## 2009-2010 DTM Project, Mississippi

# INDEPENDENT QUALITY CONTROL REPORT

## Independent Quality Control Report

Figure 11- TIN surface of a block of source DTM files illustrating elevation steps

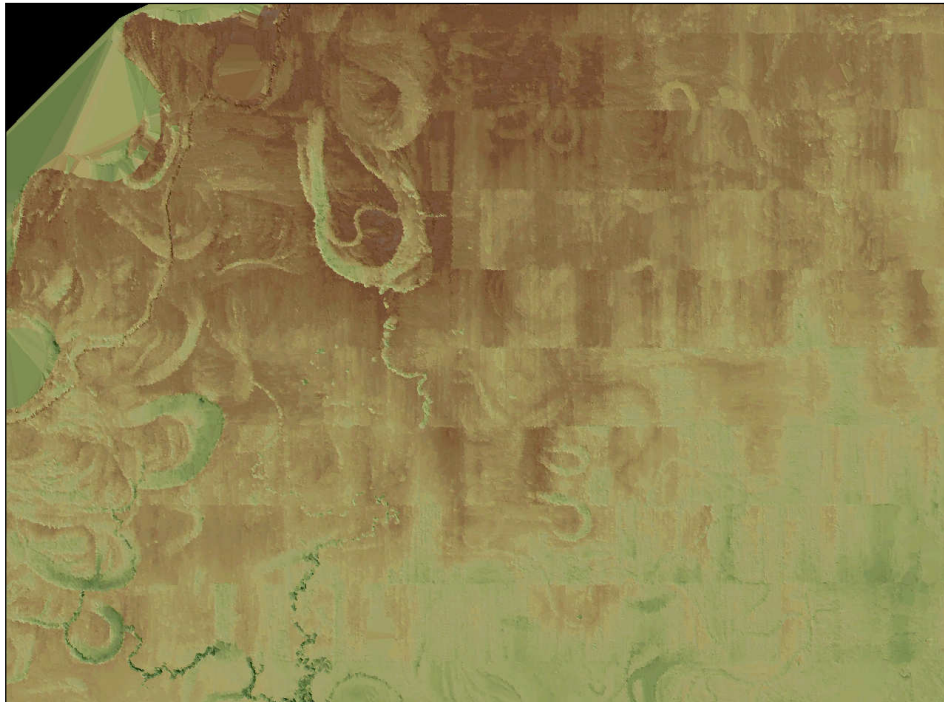
The table 1 outlines the elevation steps identified in the initial deliveries of source DTM files:

Figure 11 illustrates the visibility of the elevation steps using a simple TIN for review of the source DTM.

Issues identified during this QA process were corrected by FEDI and redeliveries were checked to verify the corrections.

Figure 12 - Cross section showing a difference of ~5 ft between the top and bottom of the step

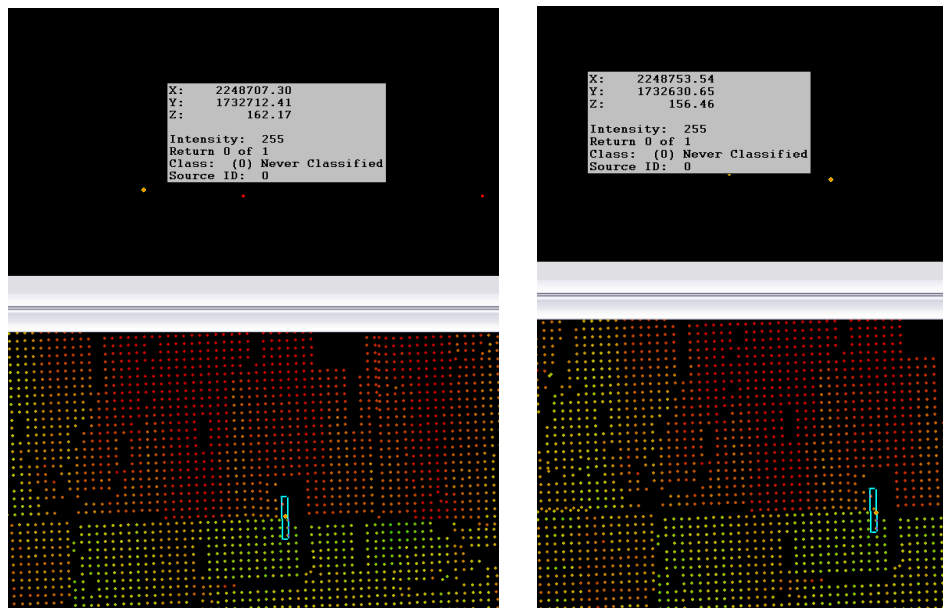
Cross sections such as the one in Figure 12 were used along identified seamlines to quantify the severity of each step and whether or not the vertical difference observed was within project specifications or not.

Figure 13 - Anomalous contour; tile 22001420\_MSW

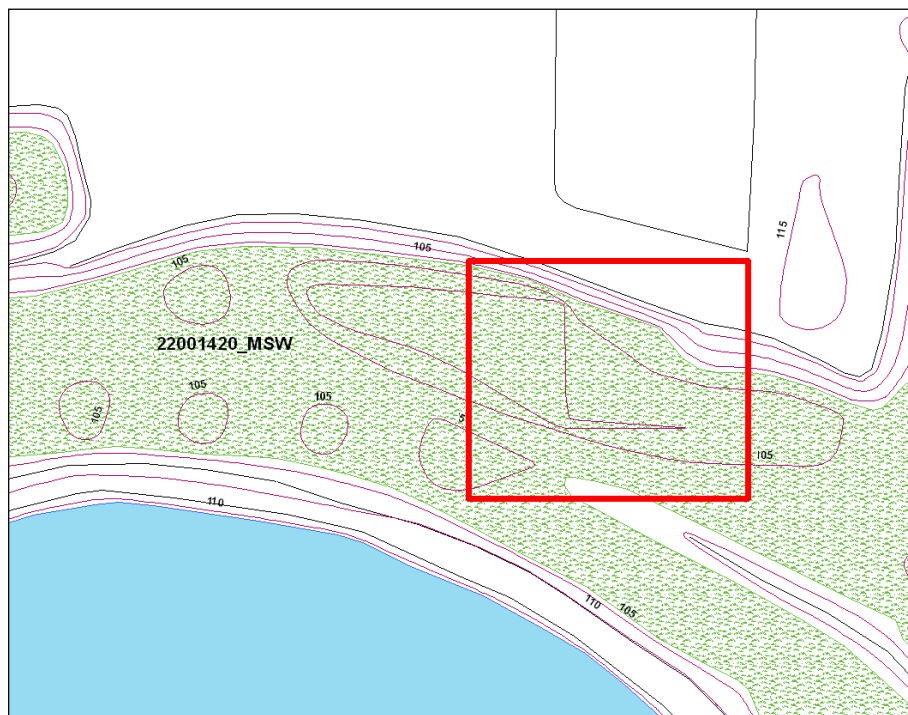
1. *Anomalous contours* – reviews of the delivered geodatabases identified instances of anomalous looking contours which would indicate that the area is not correctly depicted by the contours and possibly the DTM. Figures 13-17 are examples of identified contour anomalies identified during the QA.

Issues identified during this QA process were corrected by FEDI and redeliveries were checked to verify the corrections.

Figure 18 - Example of contour within closed water body; tile 08700780\_MSW

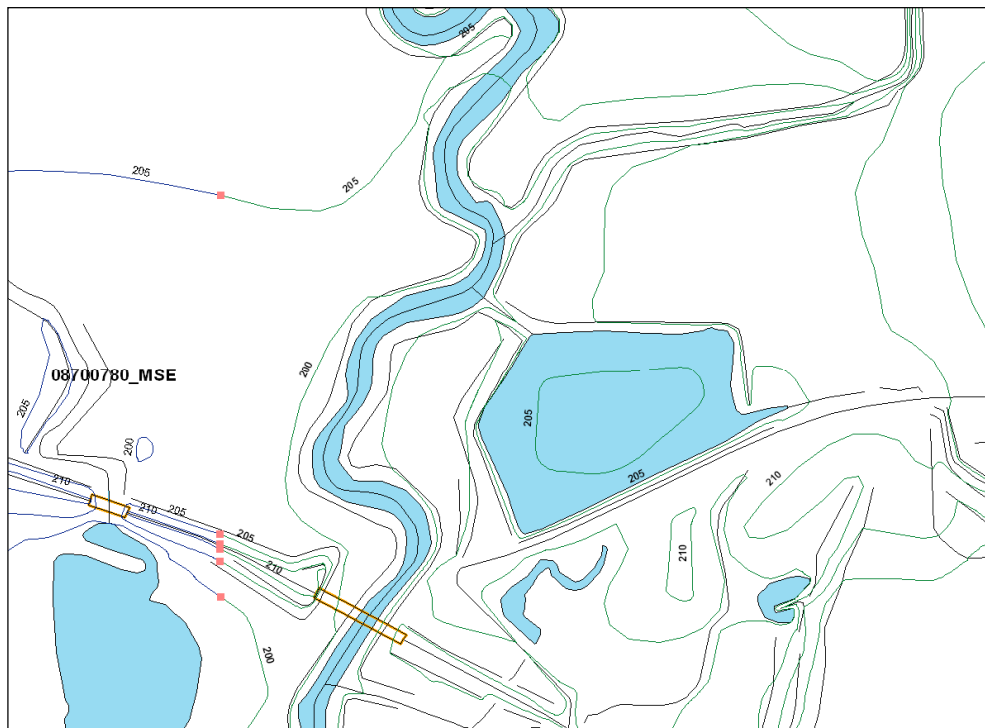
2. *Contours located within water bodies* – initial geodatabase deliveries contained errors in the contour files consisting of contour lines located within closed water bodies. Figures 18-20 are examples of this issue.

Figure 22 - Double contours crossing river; tile 11801850\_MSE

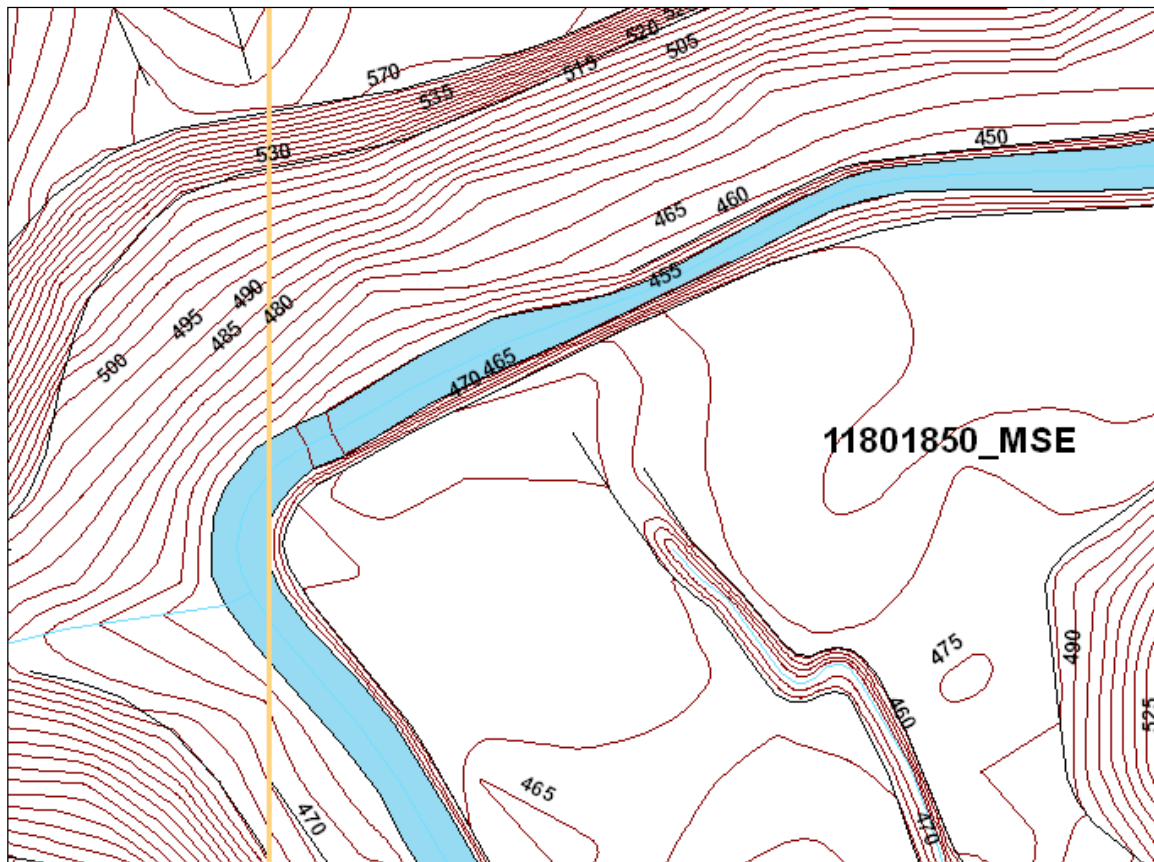
3. *Double contours crossing rivers* – Double contours of varying elevations were found in several locations that would erroneously indicate a severe drop in

elevation at the crossing (such as a dam or waterfall). In some instances, these were identified as being caused by temporal differences in the imagery where flooding had occurred. However, some of the calls were valid as errors. Figures 21-22 are examples of this issue.

Figure 23 - Example of contours containing overshoots/dangles. Yellow contours are from contour file adjoining the purple contours; tile 07101890\_MSE

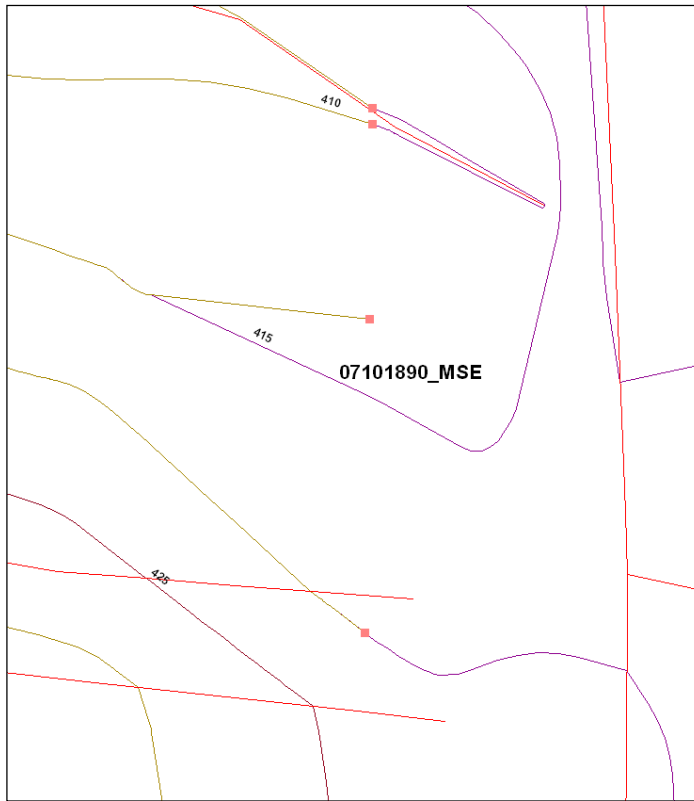
4. *Overshoots/dangles and gaps in contours* - QA of the seamlines along adjoining blocks and contour files identified issues with the seamless transition of contours over the edges of blocks and/or files. These included:
  - a. *Overshoots/dangles* - where the end of a contour from one area connects to but overshoots the identical contour in the adjoining area
  - b. *Gaps* where a contour is broken by a block or file edge
